Subject: Duke Energy Carolinas, LLC (Duke Energy)
McGuire Nuclear Station, Units 1 and 2
Docket Numbers 50-369 and 50-370

License Amendment Request for Changes to Technical Specification Table
3.3.1-1, Reactor Trip System Instrumentation, Function 16(e)

LICENSE AMENDMENT REQUEST FOR CHANGES TO TECHNICAL SPECIFICATION
TABLE 3.3.1-1, REACTOR TRIP SYSTEM INSTRUMENTATION,
FUNCTION 16(e)

FIGURE 1
CURRENT LOCATION OF TRANSMITTERS PT505/PT506

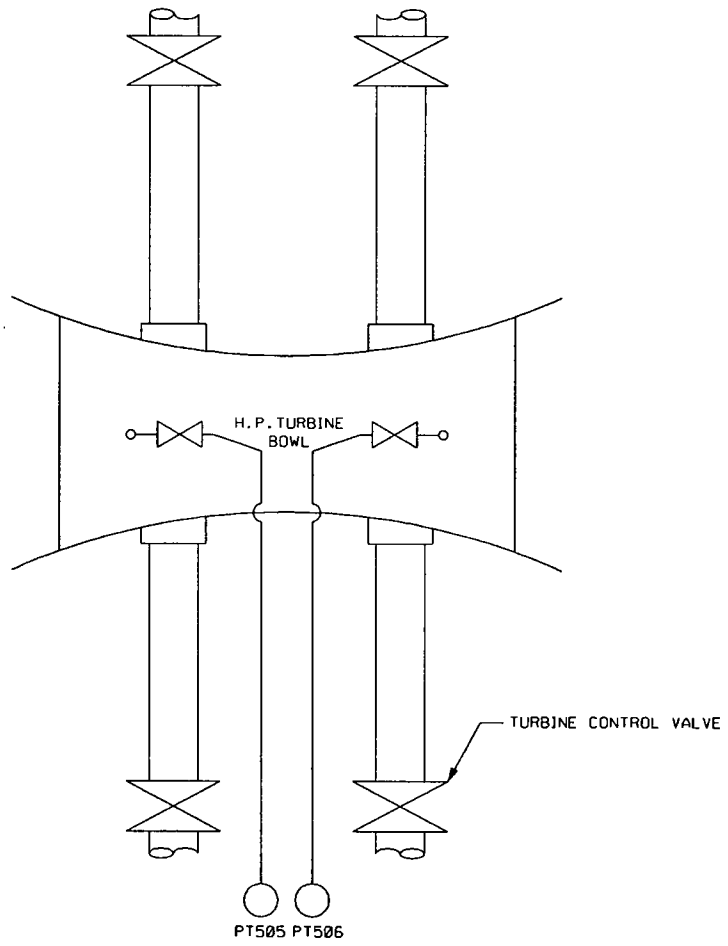
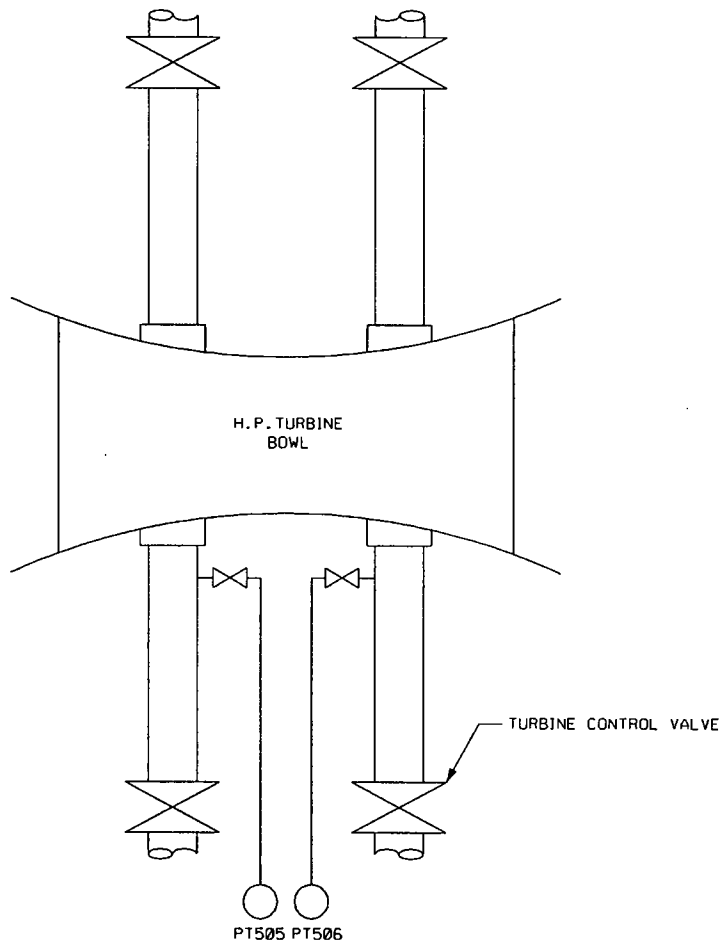
The turbine redesign moves the pressure sensing taps for instrument loops PT505/506 to just upstream of the inlet steam admission ring, but downstream of the turbine governor valves. The current PT505/506 locations are shown in enclosed Figure 1. The new locations for the transmitters are shown in Figure 2. Both existing and new pressure tap locations are functionally equivalent for their respective turbine designs in that they both

measure the inlet pressure to the first full-arc stage which can be used as an indirect reactor power pressure equivalent.

FIGURE 2
RELOCATED PRESSURE TRANSMITTERS PT505/PT506
